**FINAL ALTERNATIVES ASSESSMENT
OF
INTERIM RESPONSE ACTIONS
FOR
OTHER CONTAMINATION SOURCES
MOTOR POOL AREA
NOVEMBER 1989
CONTRACT NO. DAAA15-88-D-0022/0002
VERSION 3.1**

WOODWARD-CLYDE CONSULTANTS

**U.S. ARMY PROGRAM MANAGER'S OFFICE
FOR ROCKY MOUNTAIN ARSENAL CONTAMINATION CLEANUP**

Re: Rocky Mountain Arsenal (RMA)
Alternative Assessment of Interim
Response Actions for Other
Contamination Sources: Motor
Pool Area, September 1989.

**Figure 1-1 MOTOR POOL AREA
VICINITY MAP**

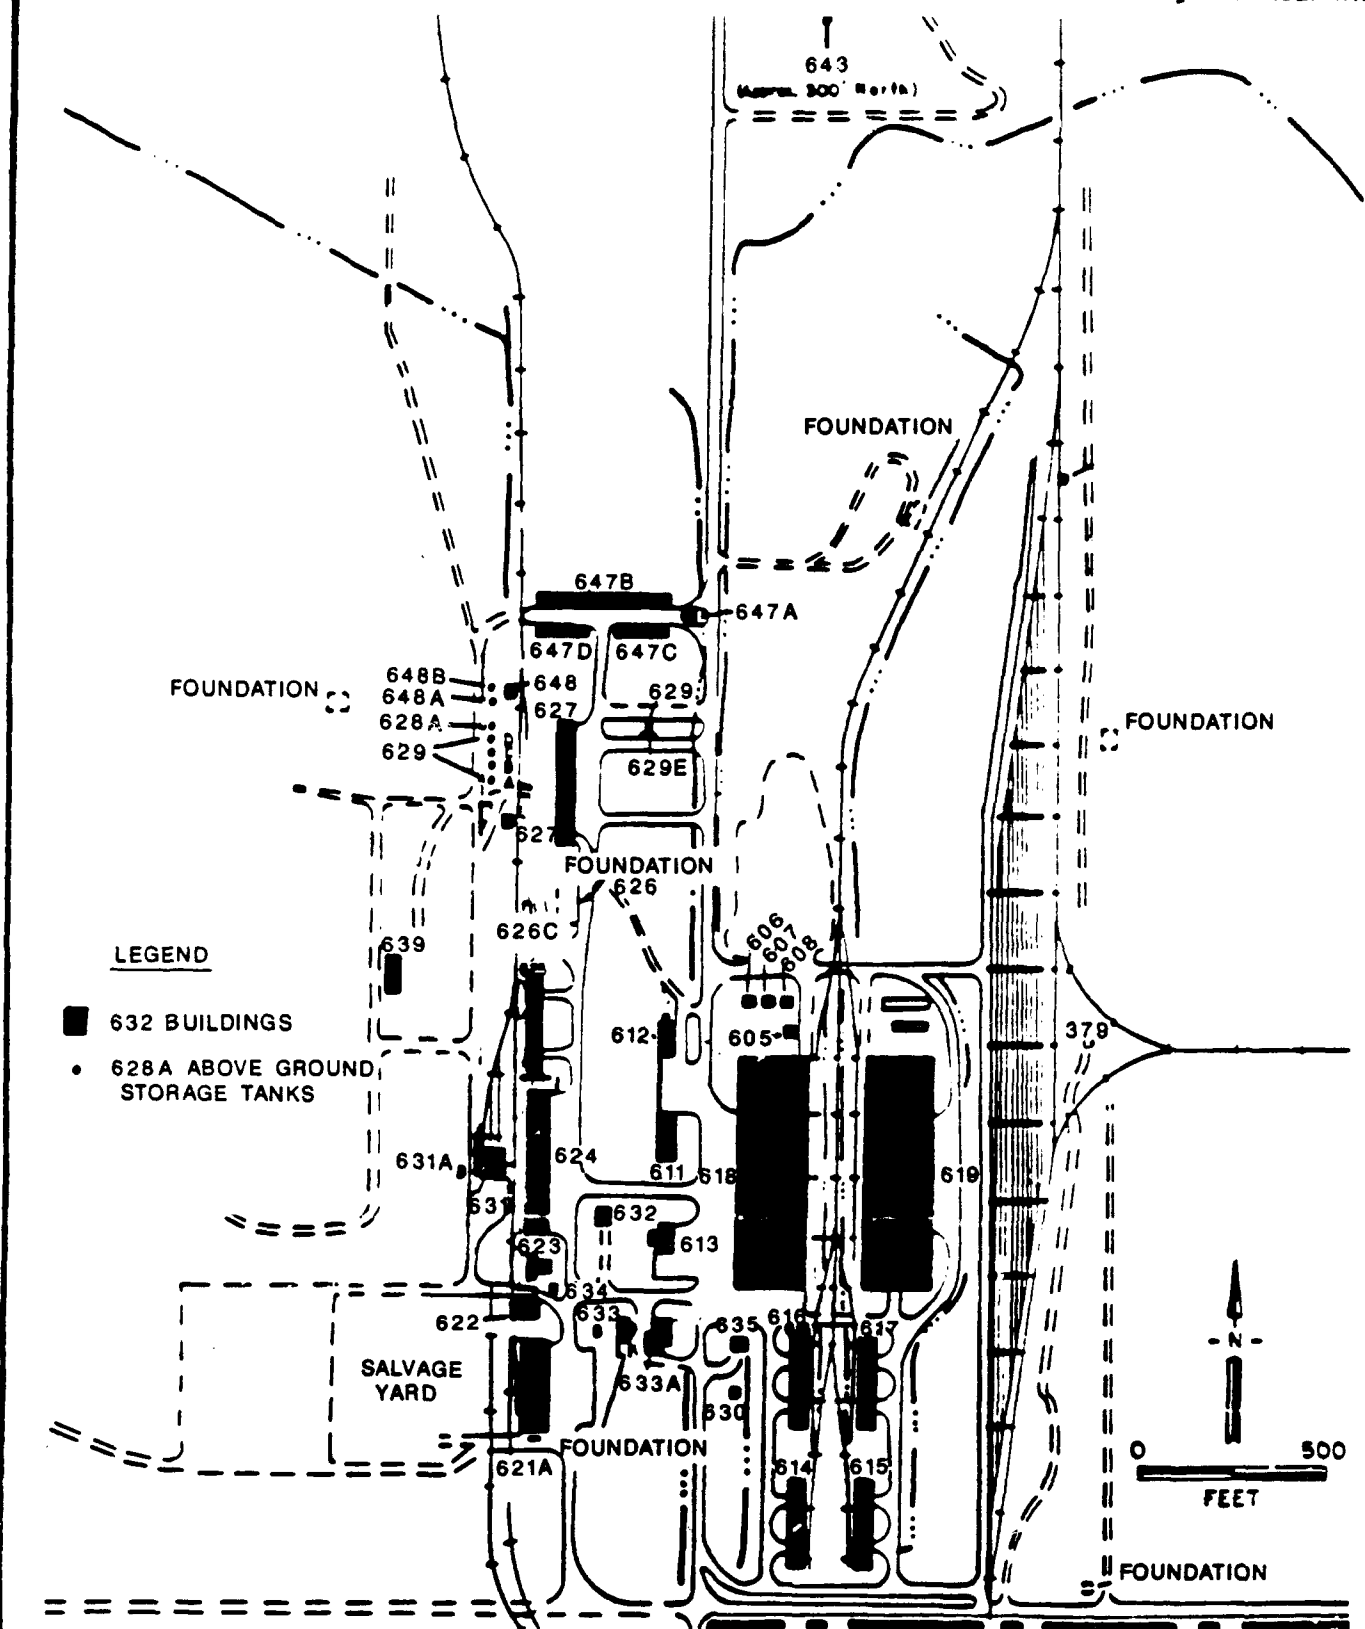
Comment 2: Figure 1-1 - The legend for this figure is not clear and should therefore be corrected.

**Figure 1-2 - DECISION FLOW CHART FOR
INTERIM ACTION VERSUS
MONITORING/MAINTENANCE
ON HOT SPOT IRAs**

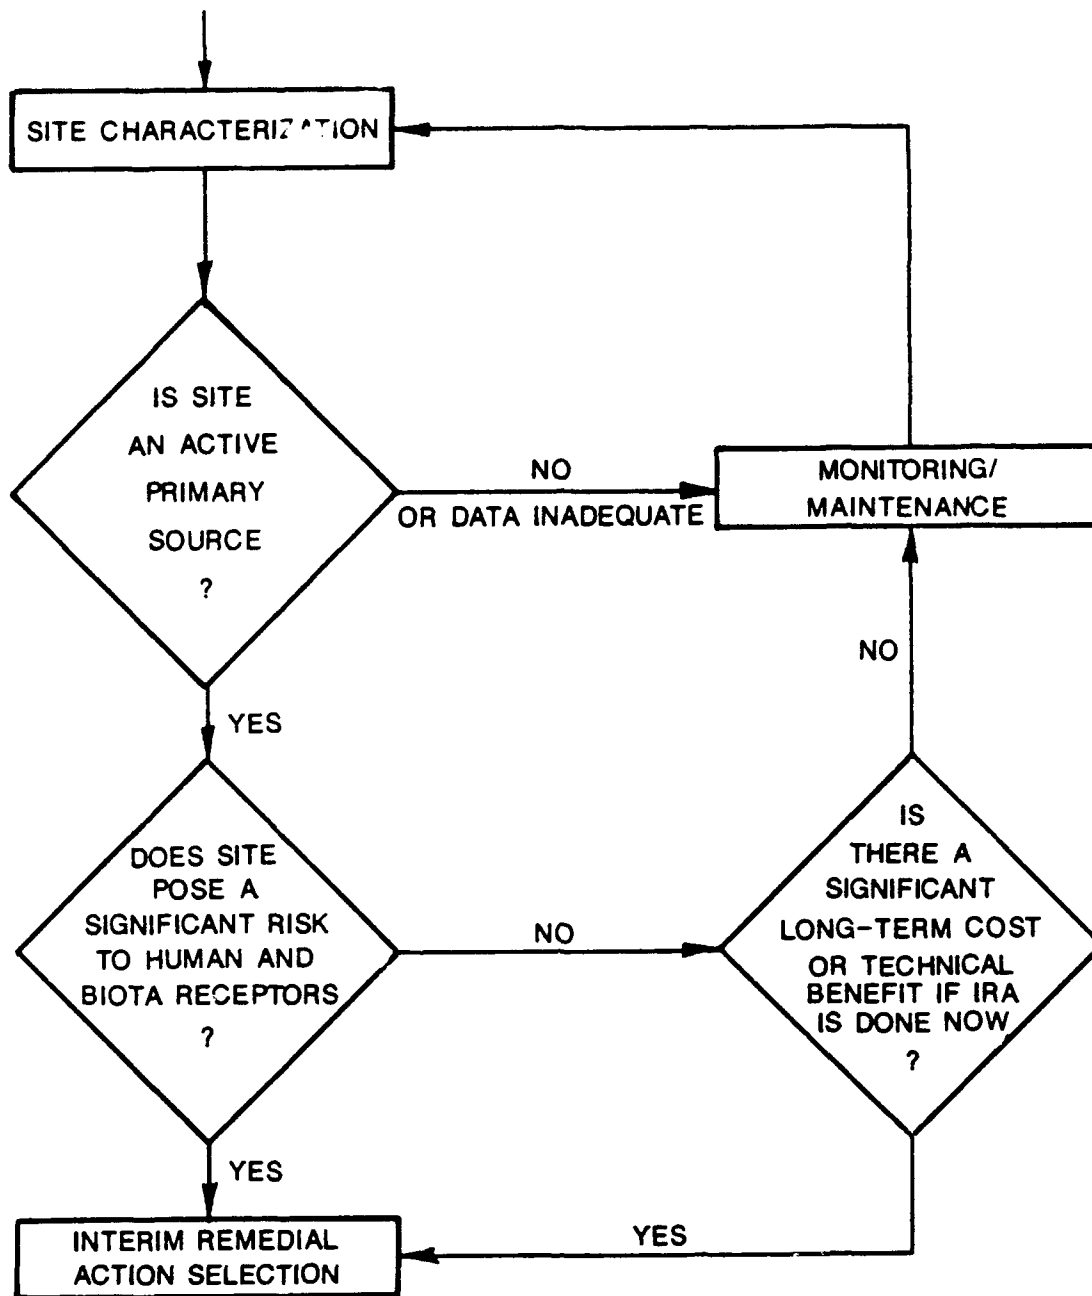
Comment 3: Page 1-3 & 1-4 - The candidate selection criteria discussed on pages 1-3 and 1-4 do not accord with the flow chart presented as Figure 1-2. Specifically, the flow chart's initial diamond which presents the threshold question of whether the site is an active, primary source of contamination does not limit that question to an assessment of the site's effect on ground water. Such a limitation was expressly disapproved by State representatives at the June 7, 1989 subcommittee meeting which was held to discuss screening criteria for the "other sources" IRA.

Comment 3: The Decision Flow Chart presented in this assessment (Figure 1-2) is an altered version of the Flow Chart actually agreed to by the Organizations and the State at the June 7, 1989 Other Contamination Sources Subcommittee meeting. Specifically, Data Inadequate should be on the NO leg of the first decision node, not on the YES node. The version agreed to is shown in Figure 1-1 of the final Technical Plan.

**Figure 2-1 WATER TABLE ELEVATIONS,
GENERALIZED GROUND WATER FLOW
DIRECTION, AND WELL LOCATIONS**

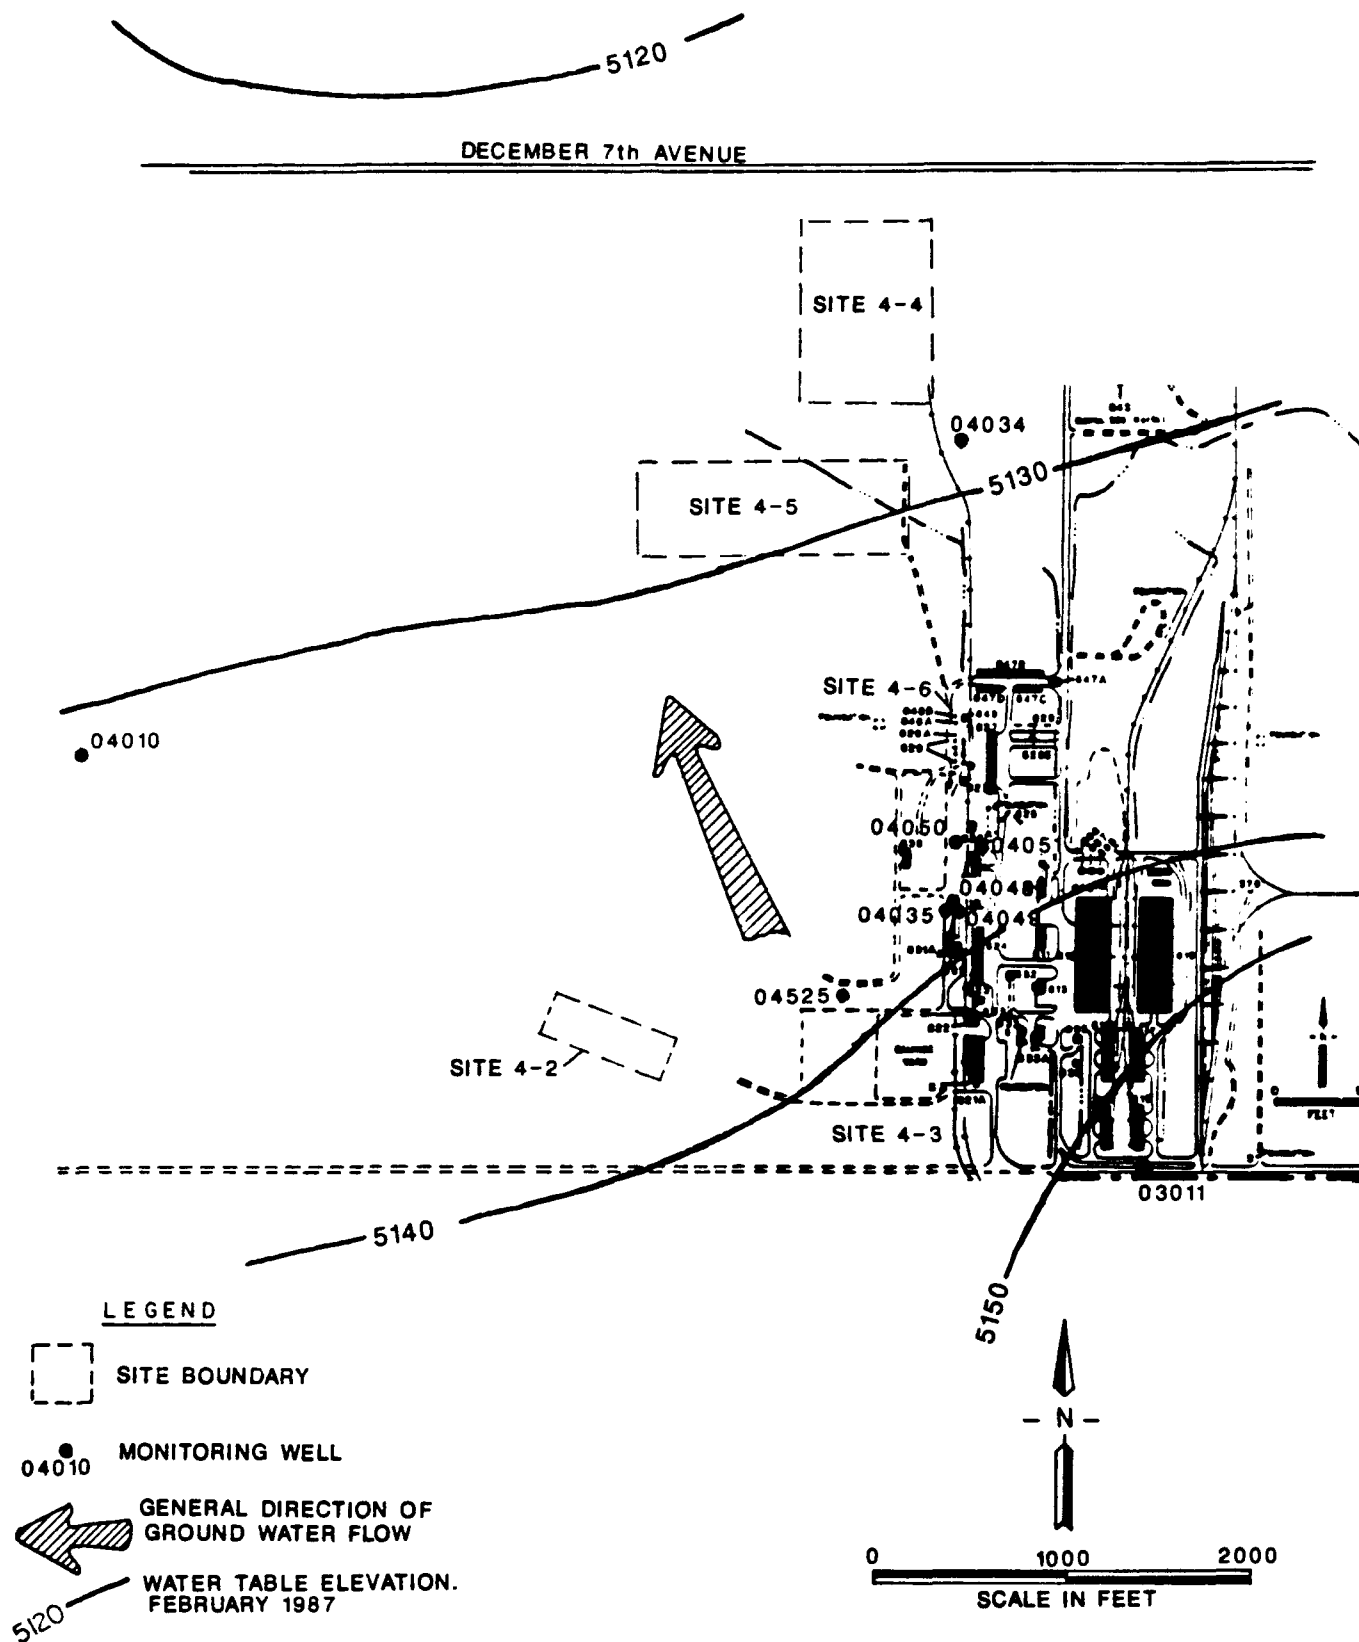
Should the reference (Table 2-2) be (Figure 2-1) instead? Table 2-2 does not identify water quality by wells, but Figure 2-1 shows well locations but no water quality data. It would be helpful if a TCE plume map were provided in this Section.

**FIGURE 2-2 TCE SOIL GAS
SURVEY MOTOR POOL AREA**

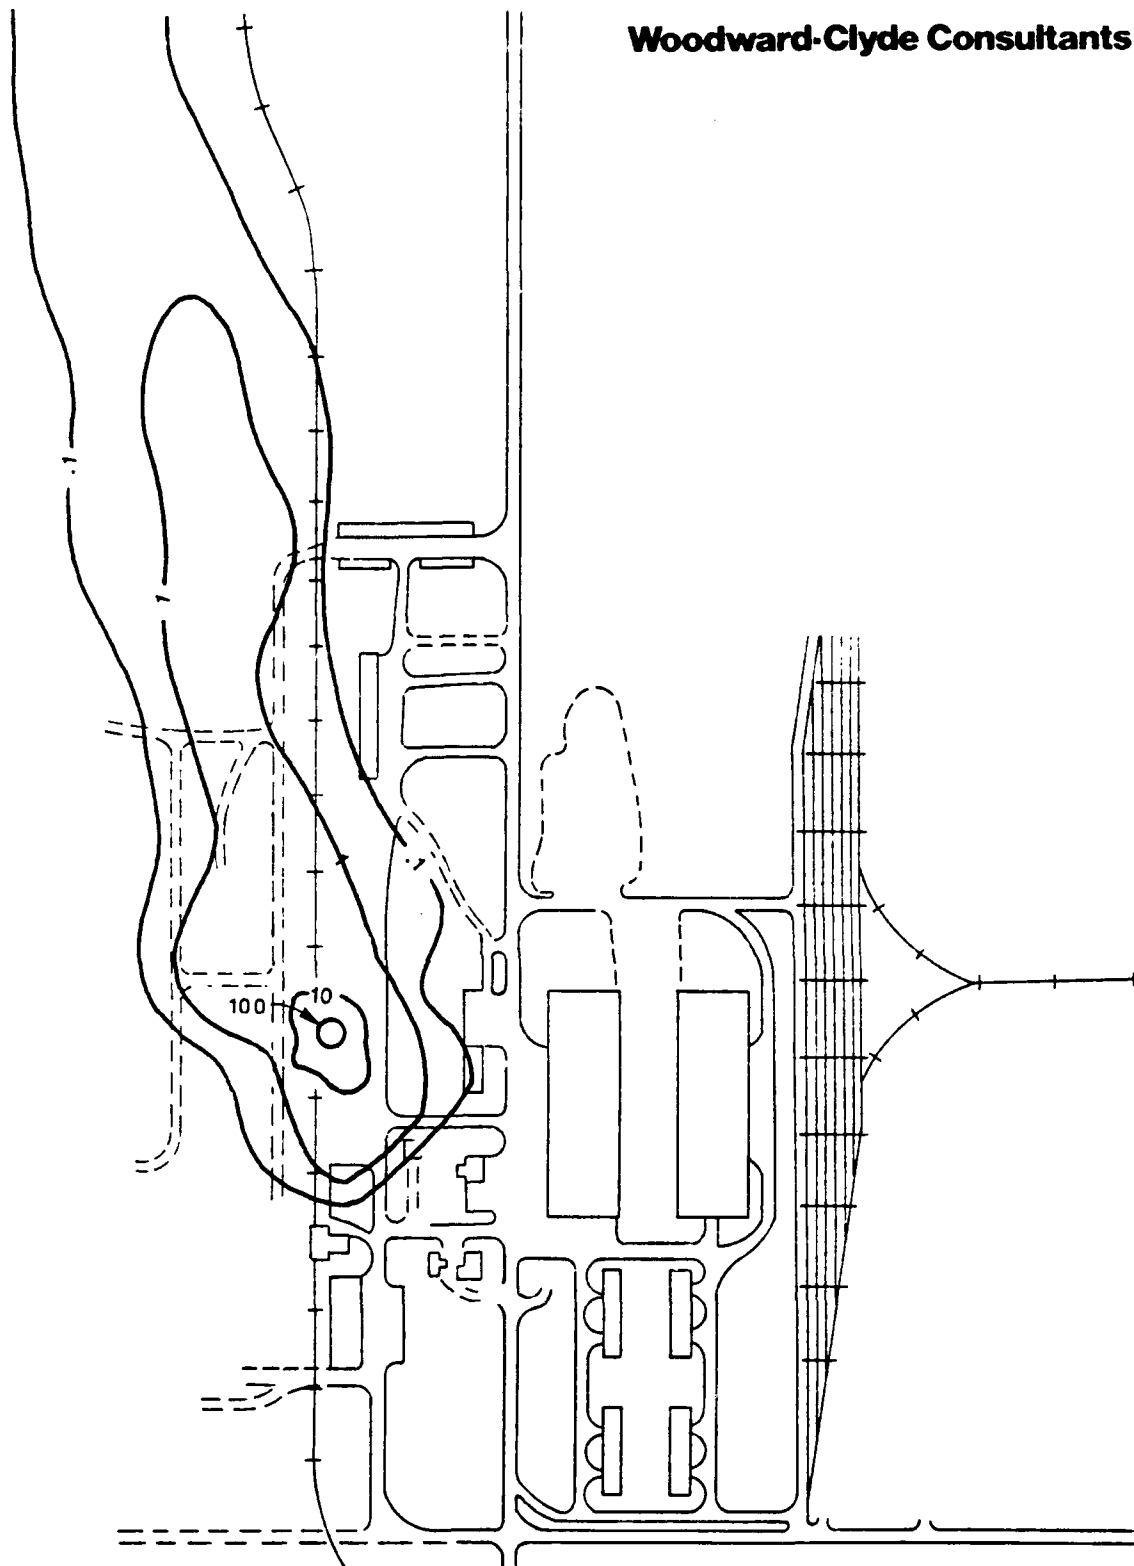
The standard soil gas sampling depth is stated as 15 feet in the text but appears to be 5 feet on Figure 2-2. Which is correct? Figure 2-2 is very difficult to read and the locations of the buildings should be made clear. Also, soil gas concentrations are not shown for many of the 5-foot sample locations.

No data are presented to substantiate this statement. Maximum sampling depth in the 1989 soil gas sampling program was described as 15 feet, although Figure 2-2 shows one sample point at 20 feet at location G5. No significant attenuation of the TCE concentration occurred at this depth.

Response: Figure 2-2 has been revised to provide a better summary of results for the purposes of this document. The standard sampling depth was 15 feet -- the figure was incorrect. Details of the investigation and results can be found in the Field and Laboratory Investigation Report (WCC 1989).
